**SUBDIVISION &  
PLANNED UNIT DEVELOPMENT  
STAFF REPORT**

**Date: October 19, 2017**

<b><u>APPLICANT NAME</u></b>	Lipscomb Landing Estates Subdivision
<b><u>SUBDIVISION NAME</u></b>	Lipscomb Landing Estates Subdivision
<b><u>DEVELOPMENT NAME</u></b>	Lipscomb Landing Estates Subdivision
<b><u>LOCATION</u></b>	3531 & 3535 Lipscomb Landing (Northeast corner of Lipscomb Landing and River Oaks Drive).
<b><u>CITY COUNCIL DISTRICT</u></b>	District 4
<b><u>PRESENT ZONING</u></b>	R-1, Single-Family Residential District
<b><u>AREA OF PROPERTY</u></b>	<b>Subdivision:</b> 4.1± Acres / 6 Lots <b>Planned Unit Development:</b> 22.1± Acres / 11 Lots
<b><u>CONTEMPLATED USE</u></b>	Subdivision approval to create six legal lots of record from four metes-and-bounds parcels; and <i>Planned Unit Development Approval to amend a previously approved Planned Unit Development to allow a residential development served by a private street.</i>
<b><u>TIME SCHEDULE FOR DEVELOPMENT</u></b>	Not specified
<b><u>ENGINEERING COMMENTS</u></b>	<b>Subdivision:</b> <b><u>FINAL PLAT COMMENTS</u></b> (should be addressed prior to submitting the FINAL PLAT for review and/or signature by the City Engineer): <ul style="li

# SITE PLAN

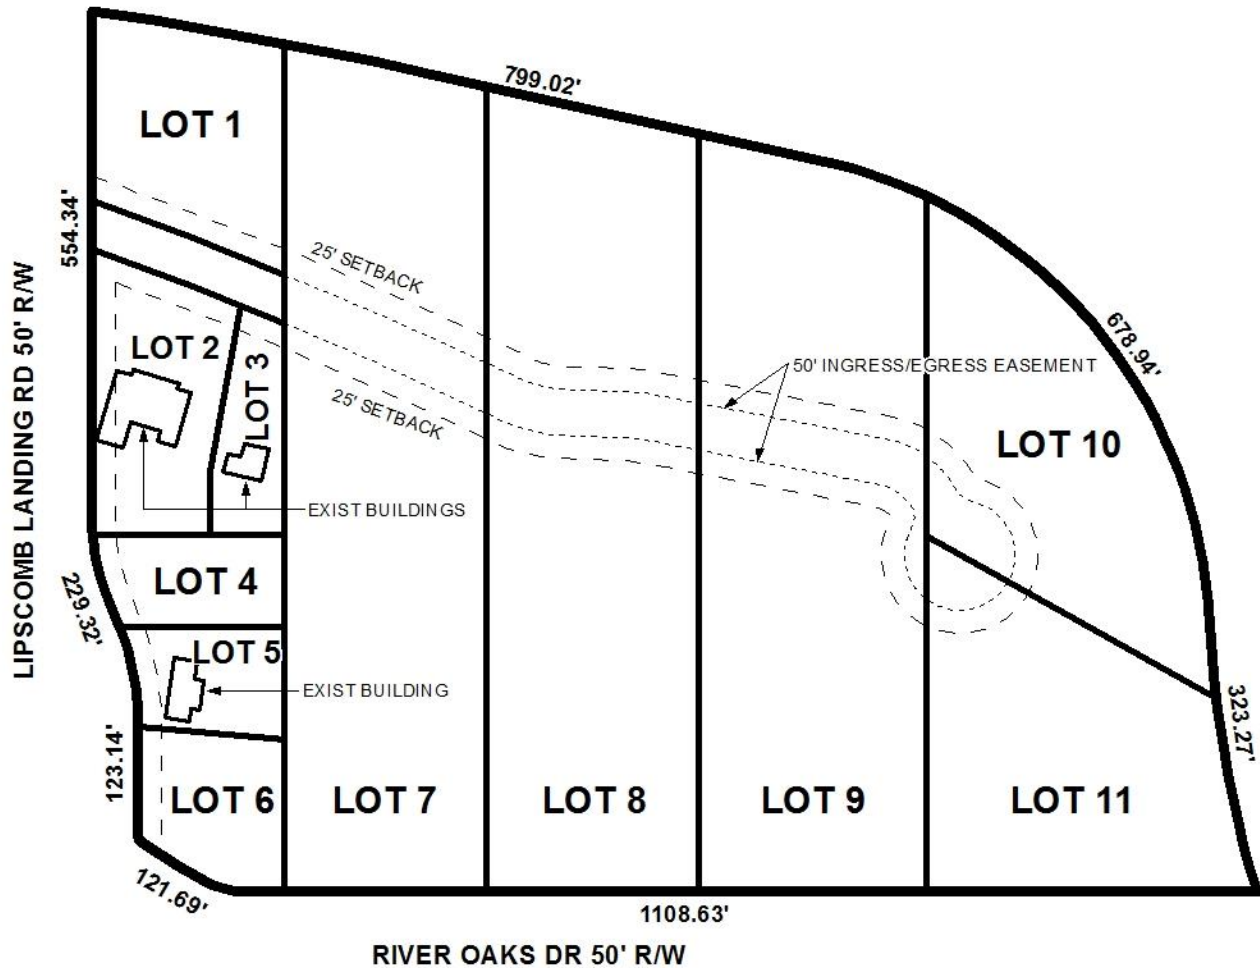
*The revised preliminary plat has been altered to specifically label the ingress/egress easement as a 50' private road. In addition, the proposed Lots 2, 4, 5, and 6 are being identified as part of a Unit One, with proposed Lots 1 and 3 are illustrated as being part of a Unit Two. There has been no mention of phases or units in prior applications for this site.*

*The proposed Lot 3 is still illustrated as being a flag-shaped lot, with no justification provided for the irregular shape of the lot.*

*Regarding the 25' setback, it is labeled along the private road for Lots 1 and 3, but not illustrated. As mentioned previously, the setback along Lipscomb Landing should be revised to be 30' to accommodate future right-of-way for Lipscomb Landing as dedication would result in an existing structure being located in the right-of-way.*

- 2) revision of the minimum building setback along Lipscomb Landing to be 30';*
- 3) illustration of the 25' minimum building setback along the proposed private road;*

# DETAIL SITE PLAN

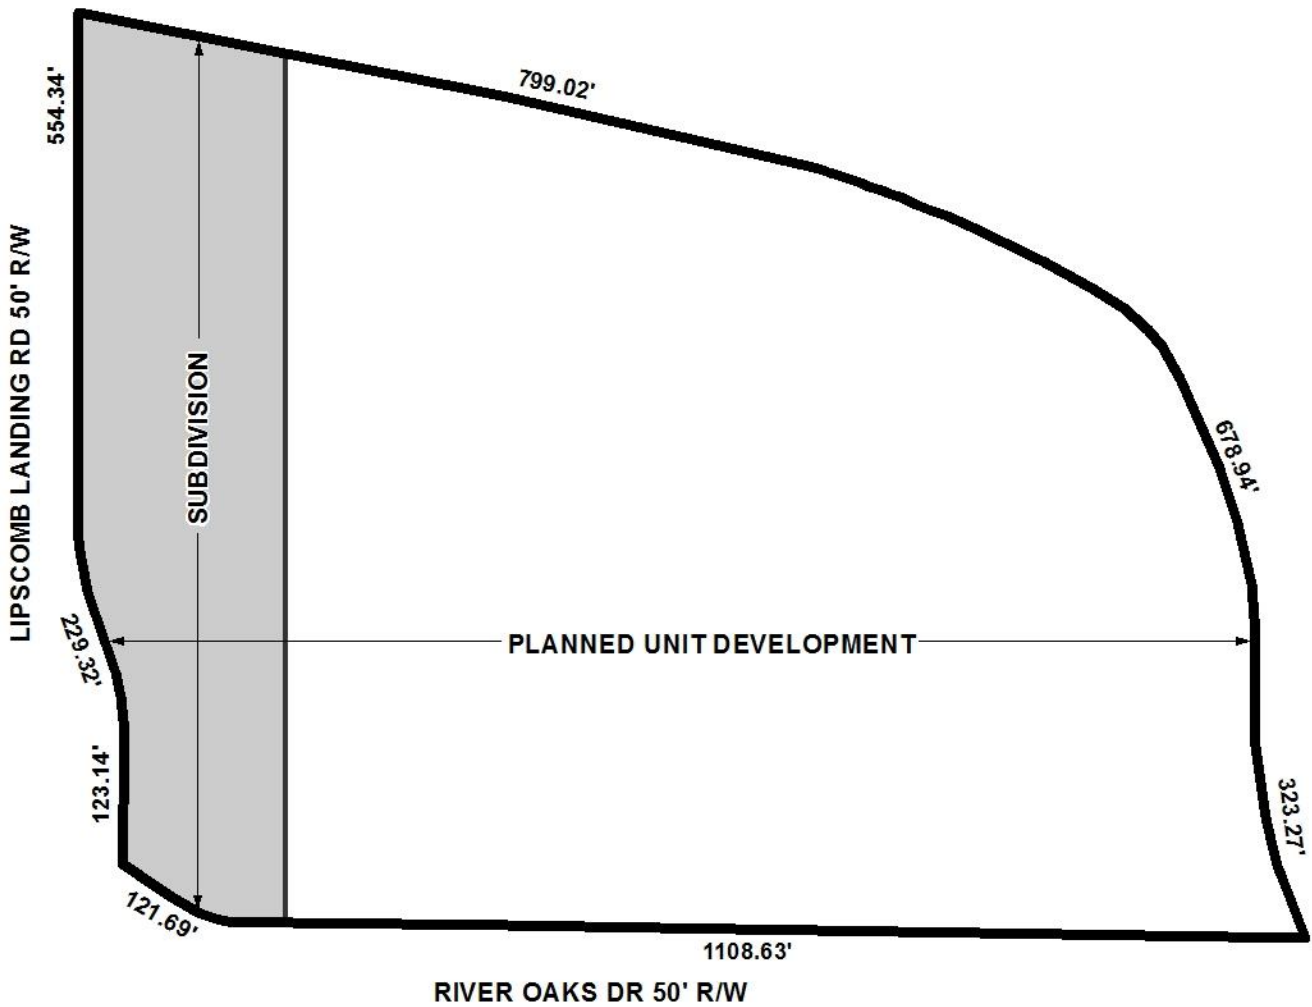
*The Planned Unit Development site plan illustrates the previously approved lot configuration for properties to the East of the subject Subdivision, and has them renumbered as Lots 7-11. While the previously approved Subdivision and PUD only illustrated a total of eight (8) lots. As the currently proposed Subdivision is now proposing the overall development be split into two phases, a new Subdivision and Planned Unit Development application should be required prior to the development of Unit Two.*

- 1) placement of a note on the site plan stating that approval is limited to Lots 2, 4, 5, and 6 of Unit One;
- 2) placement of a note on the site plan stating that prior to the development of Phase Two, a new Subdivision and Planned Unit Development application will be required;
- 3) revision of the minimum building setback along Lipscomb Landing to be 30';
- 4) illustration of the 25' minimum building setback along the proposed private road;
